CONTRACT CHANGE ORDER

CHANGE ORDER NO. 1

DATE: 12/15/15 PROJECT: The Gateway

ARCHITECT'S SUPPLEMENTAL INSTRUCTION

Revision#	M101(#1)	Sheet#	M101
Date:	10/14/15	Scale:	AS NOTED
Drawn By:	JCK	Drawing#	1 OF 1

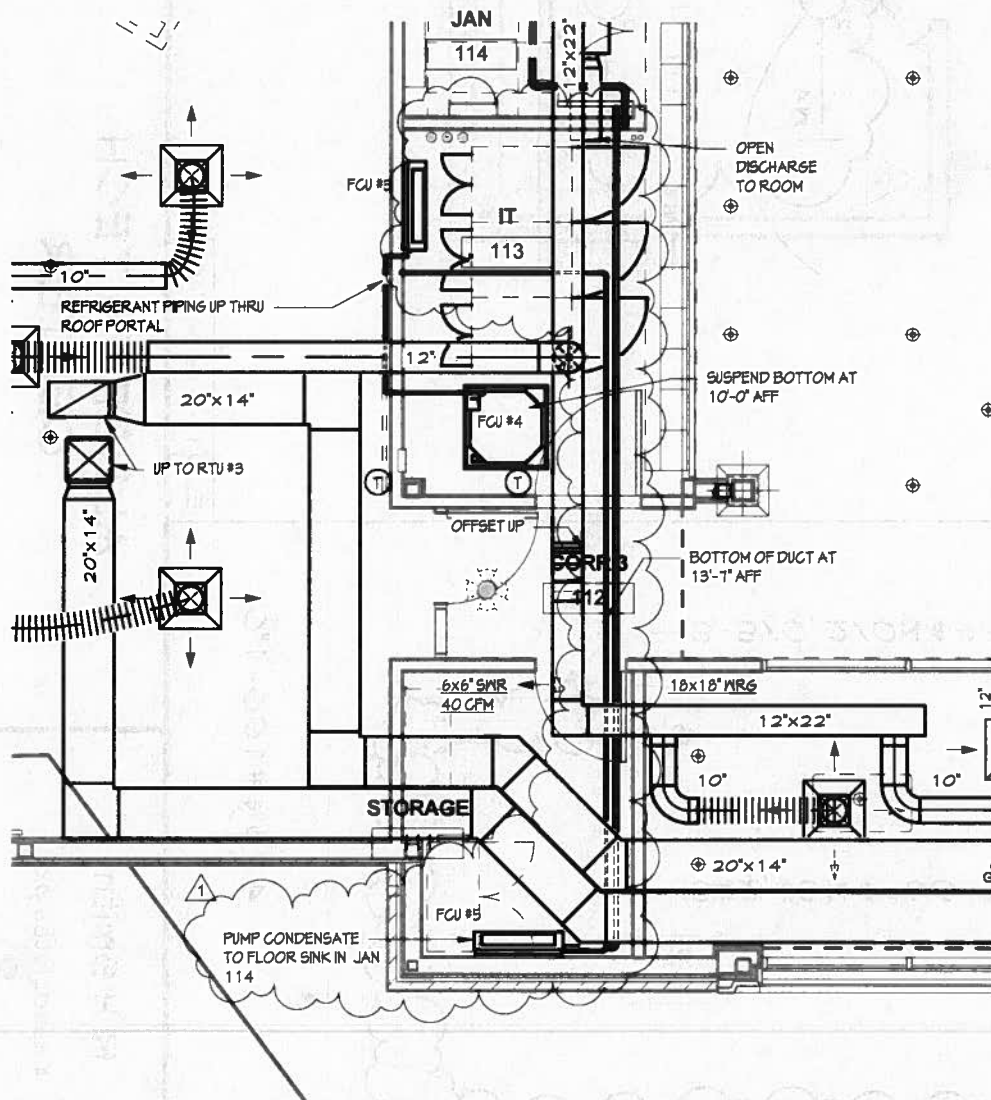
1. Sheet M101, HVAC SCHEDULE:
 - a. Add "FCU #5, FAN COIL UNIT, MITSUBISHI #PKA-A24KA, 2 TON NOMINAL CAPACITY, WALL MOUNT, WIRED WALL MOUNT CONTROLLER, CONDENSATE PUMP"
 - b. Add "AC #5, AIR CONDITIONER, MITSUBISHI #PUZ-A24NHA3, 2 TON NOMINAL CAPACITY, 17 SEER, 208V/60/1, 18 MCA, 25A RECOMMENDED FUSE, BACNET INTERFACE"
2. Sheet M101, HVAC PLAN:
 - a. Mount FCU #5 8'-0" aff on south wall of I.T. 111.
 - b. Route refrigerant piping up through roof portal to AC #5 on roof.
 - c. Pump condensate to floor sink in JAN 114.
 - d. Install thermostat on North wall, next to door.
3. Sheet M102, ROOFTOP HVAC PLAN:
 - a. Mount AC #5 on equipment rails north of AC #3.

EOO1 - NO SCALE

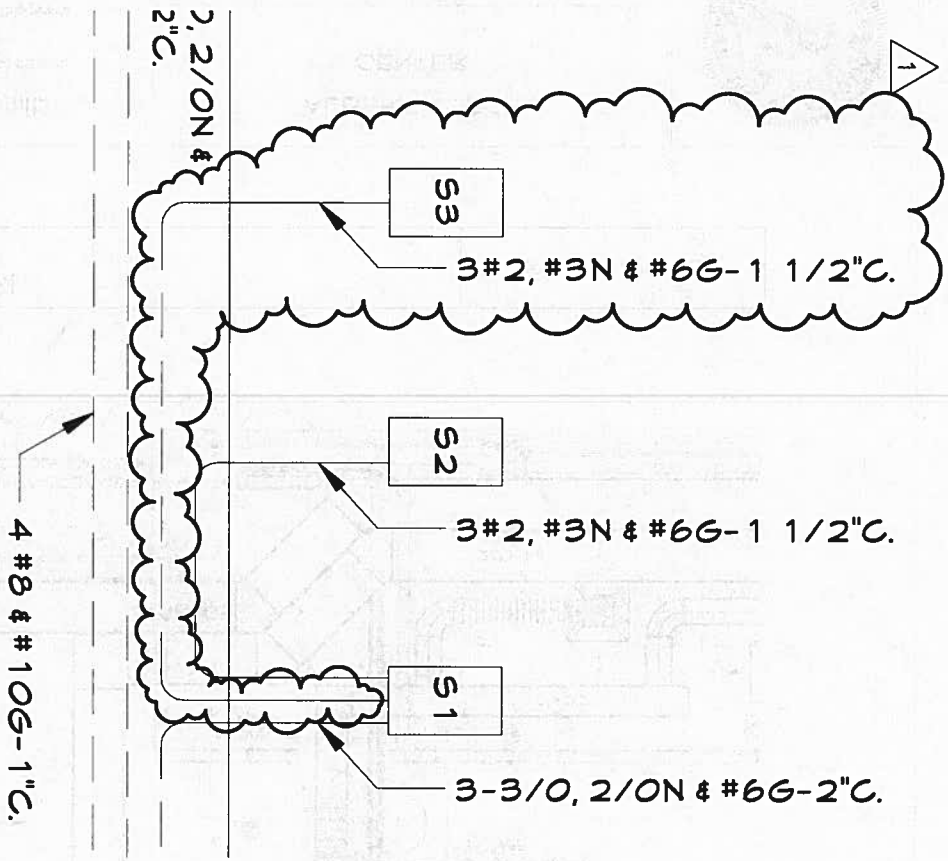
1. Sheet E001, Riser Diagram: See attached sheet (1 of 1) for revisions.
2. Sheet E002: (Sheet Reissued) See sheet for revisions.
3. Sheet E101: (Sheet Reissued)

E201 - 1/4" = 1'-0"

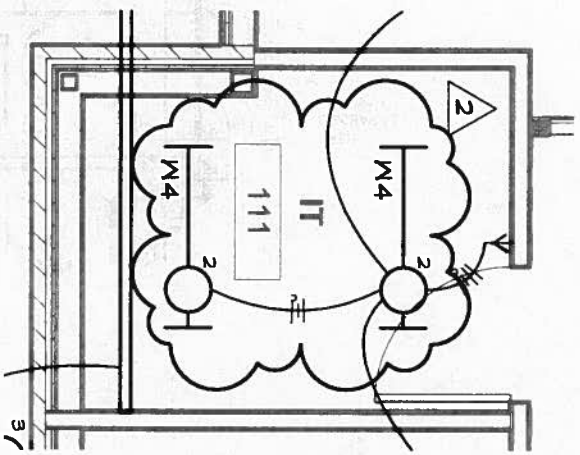
- 5. Sheet E201, I.T. 111: See attached sheet (1 of 1) for revisions.
- 6. Sheet E301: (Sheet Reissued)
 - a. Revised 'Auxiliary General Note'.
 - b. Auxiliary Symbol List:

1 Roof Power Wiring And Upper Area Lighting Plan
 SCALE: 1/4" = 1'-0"

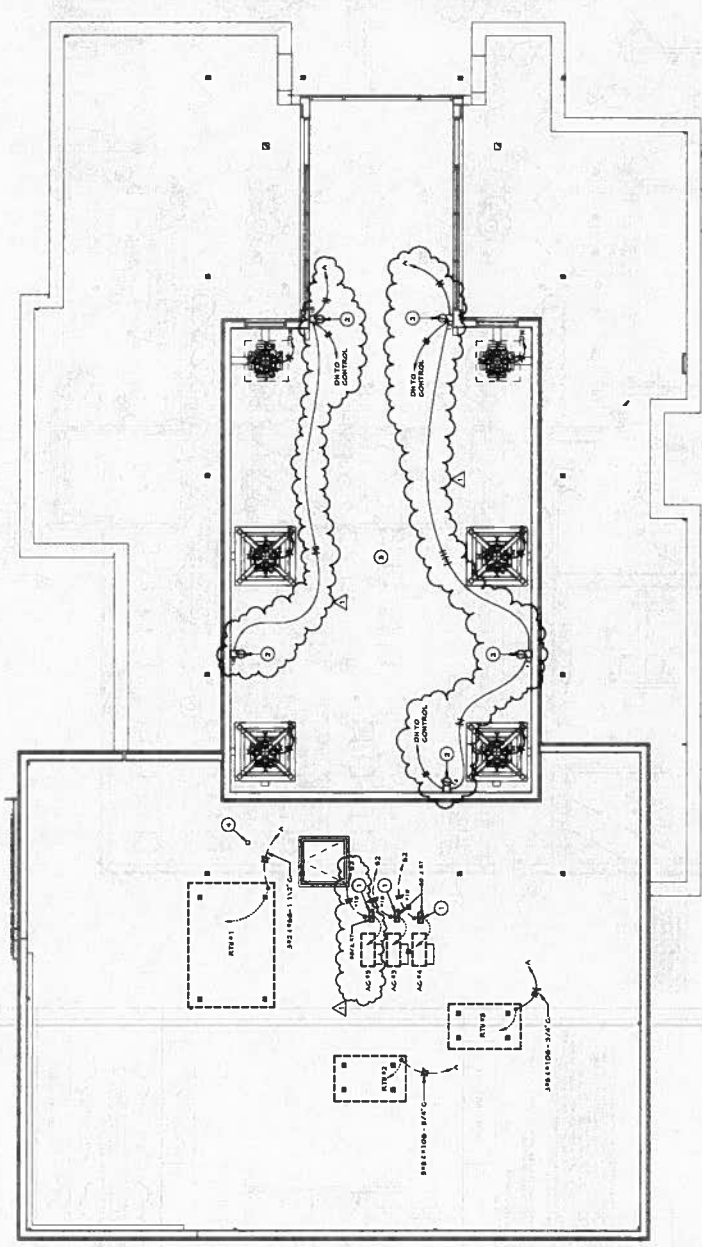
- v. Added motorized shade controls.
- 4. Sheet E102: (Sheet Reissued)
 - a. Revised specific note 2.
 - b. Revised motorized shade provisions.
 - c. Added connection to new AC #5.

E301 - OPEN AREA 107

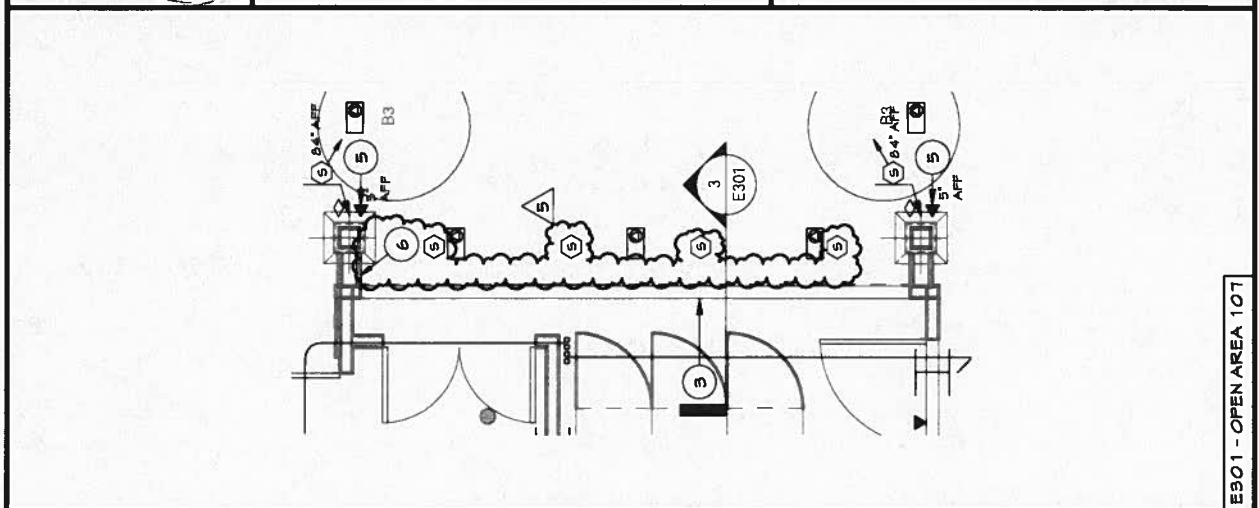
1. Sheet E002, Panel 'A' Schedule:
 - a. Reassigned circuits as shown below:
 - i. Circuit 50: Recept. – Video Wall Speakers
 - ii. Circuits 64, 66, & 68: Receptacle – Small Video Wall
 2. Sheet E101: (See attached electrical sheet 1 of 1)
 - a. I.T. 111: Add two (2) duplex receptacles.
 - b. I.T. 113: Add four (4) duplex receptacles.
 3. Sheet E201, Child Activity 110: Remove three (3) 'N2' fixtures (See attached electrical sheet 1 of 1)
 4. Sheet E301:
 - a. Specific Notes: Add specific note 6, note to read, "INSTALL DOUBLE-GANG, LOW-VOLTAGE, BOXLESS OUTLET 46" AFF WITH ¾"C. TO I.T.113' FOR FUTURE DEVICE TO BE INSTALLED BY OTHERS, INSTALL BUSHING ON CONDUIT END."
 - b. Open Area 107: (See attached electrical sheet 1 of 1)
 - i. Relocate three (3) future ceiling speaker locations.
 - ii. Add one (1) future ceiling speaker location.
